Comment by Friends of Lye Valley (FoLV) on :

**Re: Geotechnical Engineering, WARREN CRESCENT, HEADINGTON, OXFORD  
SLOPE STABILITY APPRAISAL, Report Ref: 36045 for by R J Leighfield & Sons Limited  
Date 09/10/2020. (Document achieved by Freedom of information request.)**

[For development at Land East of Warren Crescent, Oxford, **OX3 7NQ**. original application 13/01555/CT3 *Erection of 10 x 3-bed dwellings (use class C3) together with associated car parking, cycle and bin storage. Diversion of public footpath. (Amended plans and description)*]

**21.02.2021**

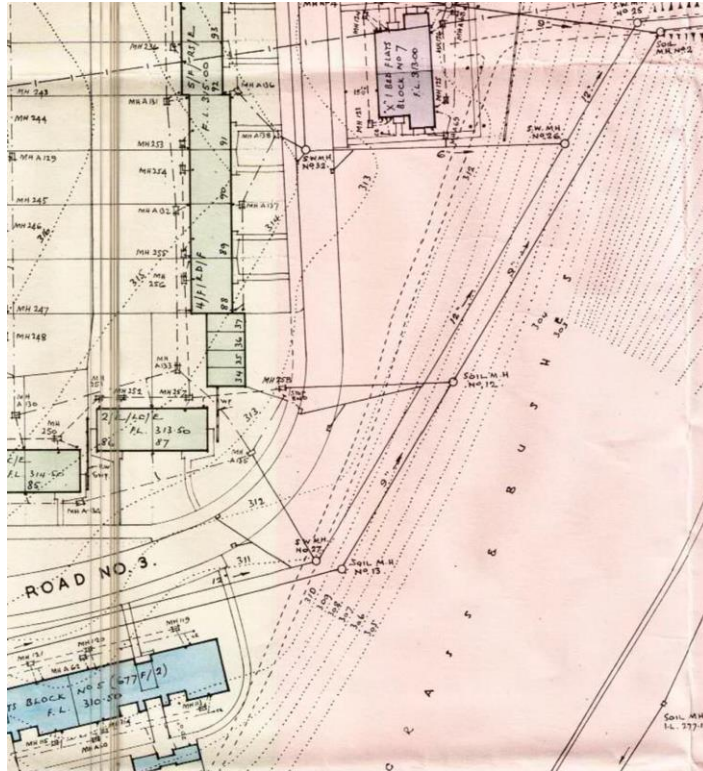
The most recent revision of plan with swale design and with re-routed footpath is by Kendall Kingscott dated 29.07.2020, (Revised Site Plan 2383340). The break in slope (cliff edge) of the tipped embankment appears to be indicated by the red line. A row of field maple trees are planted along the fence adjacent to the break in slope. Although they are not shown individually, the canopy extent of these trees is indicated and they are visible in the photo on page 1.

Geotechnical Engineering assume the roots of these trees will hold the adjacent made ground bank stable. This will obviously not be the case when the swale is constructed as the trees will have severe root damage and are likely to die.

Considering that the absolutely necessary infiltration swale of 50m long by 2m wide is really an extremely large **soakaway**, receiving a concentrated water discharge after a storm and less than 3m from the break in the slope on the southern section of the bank.....

..with the stabilising vegetation of a line of field maple trees compromised by necessary severe cutting back, **FoLV fail to see how the swale can be safely constructed at all in the planned position, quite near to the break in slope, without destabilising the tipped embankment for at least 50m length.**
